RESPONSE TO URBAN DESIGN COMMENTS & WITHOUT PREJUDICE OFFER

SUBJECT SITE: 6 & 14 STUDLEY PARK ROAD, KEW

APPLICATION NO.: PP21/0271

To allow Council to resolve the application positively and in line with our discussions with Council on 20 August 2021, we hereby submit **Sketch Plans** prepared by Woods Bagot, dated 18 August 2021.

Figure 1 - Proposed north-western deep soil zones.

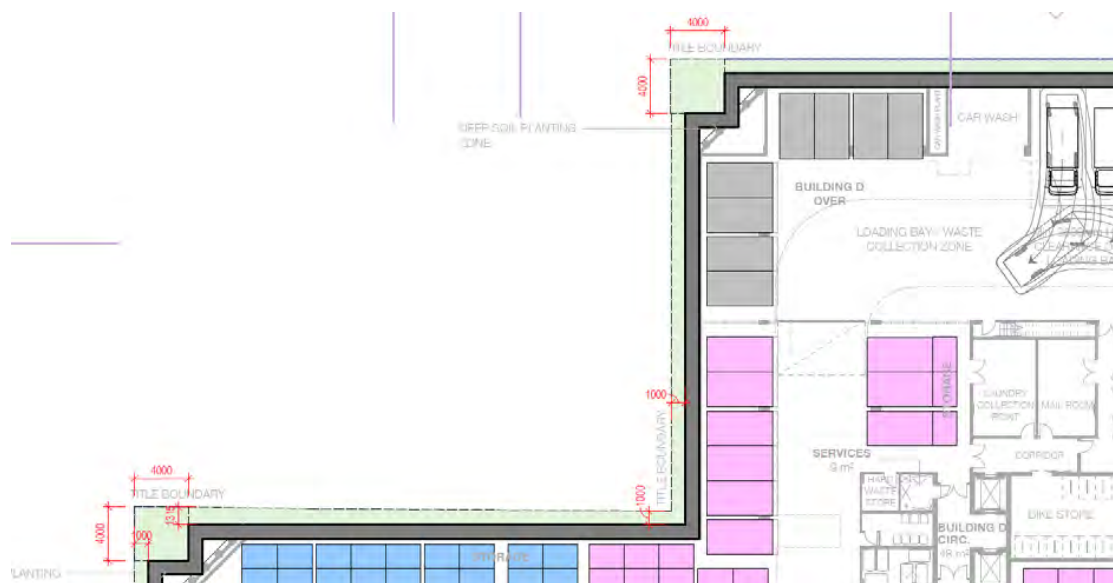
We note the Urban Design Team's concerns regarding the extent of deep soil planting along the north-western boundary to the properties on Banool Avenue. This advice has been incorporated within the enclosed Sketch Plans.

The Sketch Plans adopt three 4 metre by 4 metre (4m x 4m) deep soil planting zones which will result in a reduction in the overall basement area, minor reduction in ground floor private open spaces, and allow for large canopy trees to be planted in these locations. The provision of additional deep soil planting area will contribute to the softening of the interface between the subject site and properties along Banool Avenue, as well as the Studley Park Road frontage.

We note the inclusion of the deep soil planting pockets has resulted in a loss of one car parking space in the basement car park (186 spaces, down from 187).

Figure 3 – Current electrical kiosk (left) and proposed electrical kiosk (right) size and location.

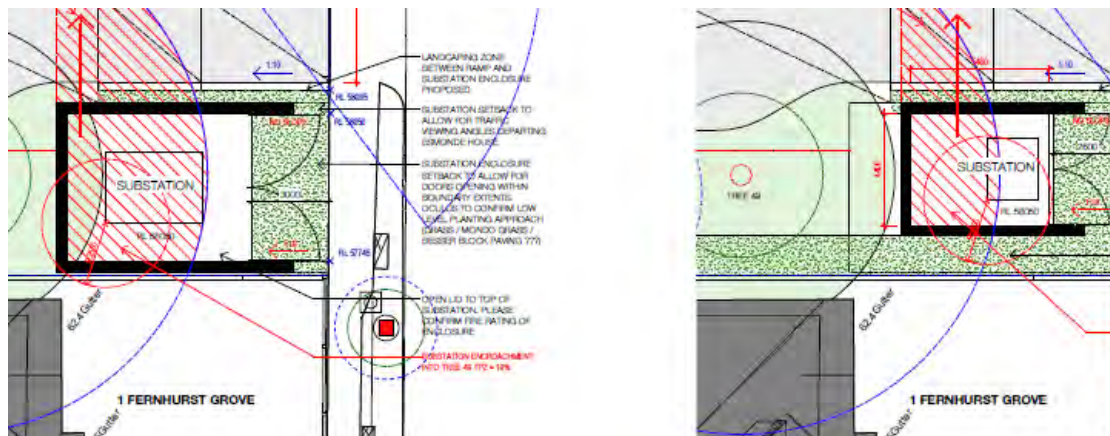
We note the Urban Design Team's comments regarding the size and location of the proposed electrical substation kiosk on the Fernhurst Grove frontage. The electrical kiosk is in the most appropriate location, considering the following:

In consultation with CitiPower, the substation has been reduced in size to a smaller 1,000kVa kiosk substation (previously 1,500kVa), which has improved setbacks to both the Fernhurst Grove street frontage and the neighbouring property at 1 Fernhurst Grove. The reduced size and minor location shift also results in the retention of Tree 49 Weeping Lilly Pilly.

The proposed electrical kiosk has been sited to reduce the visual impact to Fernhurst Grove to the greatest extent possible. We acknowledge Council's suggestion to move the location to the north of the adjacent driveway. However, this would result in additional visual impact due to the slope of the land, as well as potential impacts to existing vegetation. It is considered that the reduced size of the kiosk in the proposed location will result in minimal visual impact to Fernhurst Grove, while maintaining CitiPower access requirements.

Figure 4 – Proposed revised Building A south-western interface to 2 Banool Avenue.

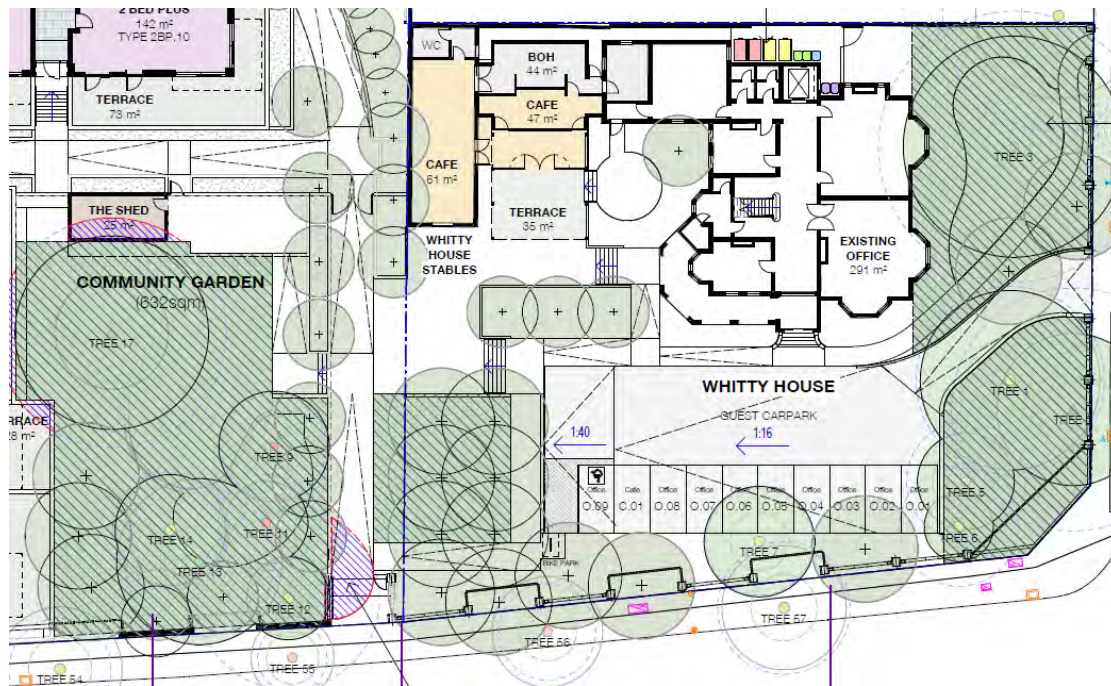
We acknowledge Council's Urban Design comments in relation to the scale and transition of Building A fronting Studley Park Road. This advice has been incorporated within the enclosed Sketch Plans.

Council's suggestion to step back the upper level of Building A has been incorporated into the design in order to create a more distinct stepped transition with 2 Banool Avenue (Figure 4). This results in a gentler transition in scale, reduced potential adverse amenity impacts, and a reduction in visual bulk when viewed from Studley Park Road and adjacent properties. We note the provided Sketch Plans are indicative and will be subject to further refinement. The proposed deep soil planting zone in the south-western corner of the site (Figure 2) will provide additional softening of the interface, as discussed in Section 2.1 of this letter.

Figure 6 – Proposed building recesses as seen from neighbouring property (6 Banool Avenue).

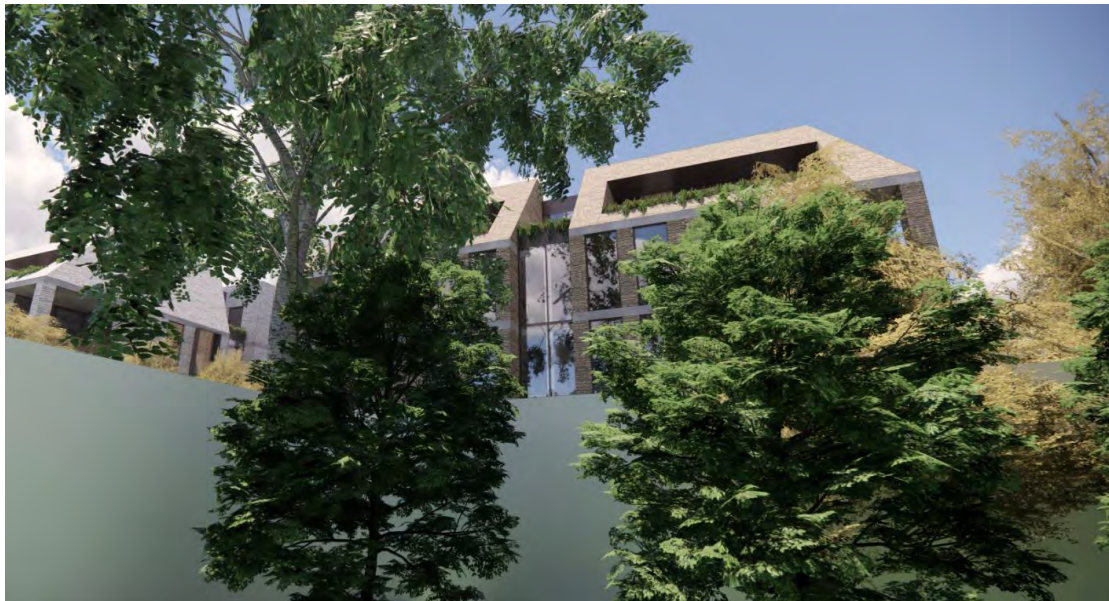
Council's Urban Design comments surrounding the northern and western interface building recesses is acknowledged. However, the existing building articulation is considered appropriate for the following reasons:

- The building recesses are currently sized at 2.4m wide x 1m deep. This is increased further at the mansard level where the recess depth is increased further to a 3m inset.
- The proposed recesses have responded to discussions held at the pre-application lodgement stage.

- Only 1-1.5 storeys of the 1m deep recess are visible above fence height before the deeper (3m) recesses take effect at the mansard level.
- The distance of Building B from the Western boundary is substantial and should be taking into account when discussing the building recesses.
- The building recesses all feature glazing for the full width, further accentuating the separation of the masonry building forms on each side and reducing the perceived visual bulk of the built form.
